Dublin Cycling Campaign,
% Tailor's Hall,
Back Lane,
Dublin 8

ASHTOWN LEVEL CROSSING

12 October 2020

Figure 9-28 Ashtown Option 4A complimentary pedestrian and cycle underpass at Ashtown
(Copyright Ordnance Survey Ireland – 0039720)

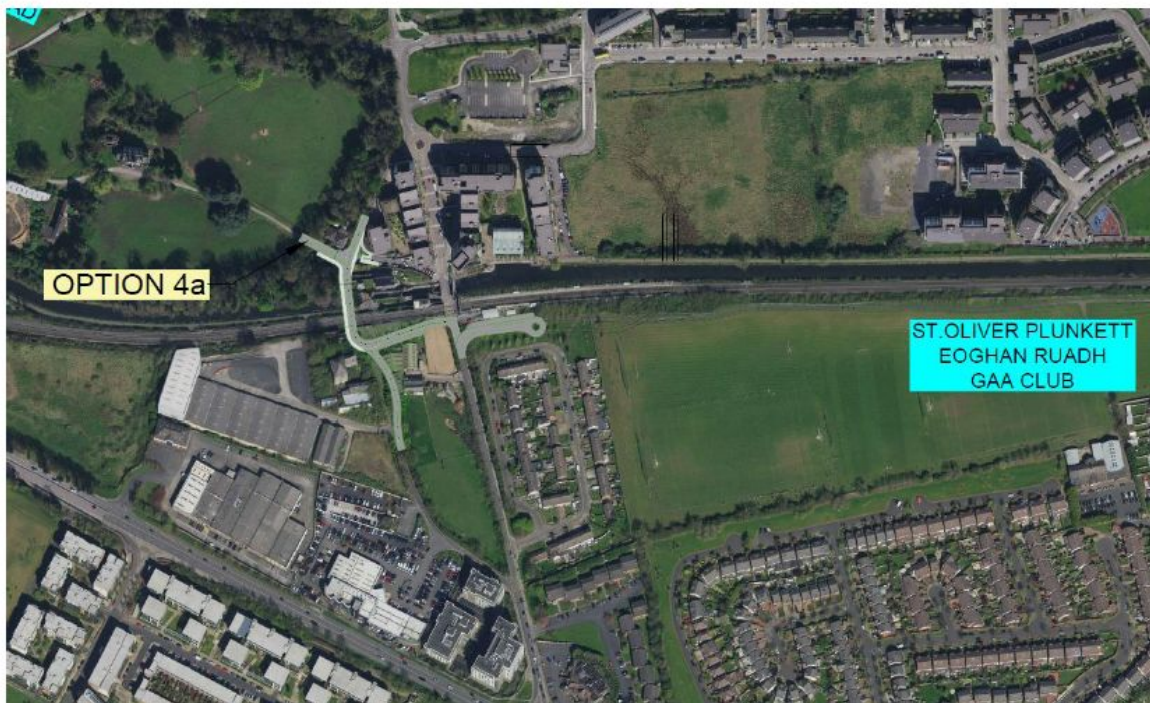
- Fingal Cycling Campaign supports Option 2 in combination with either Option 4a or Option 4b in order to support cycling and walking of all ages and abilities. Option 2 and 4a underpasses supports cycling and walking for people who are less well able to deal with the incline crossing the cycling and walking bridge as shown in 4b.

- It is unlikely that Option 4a is compatible with Option 2 so we would defer to Option 2 in combination with Option 4? Is there a possibility of doing an improved design? .
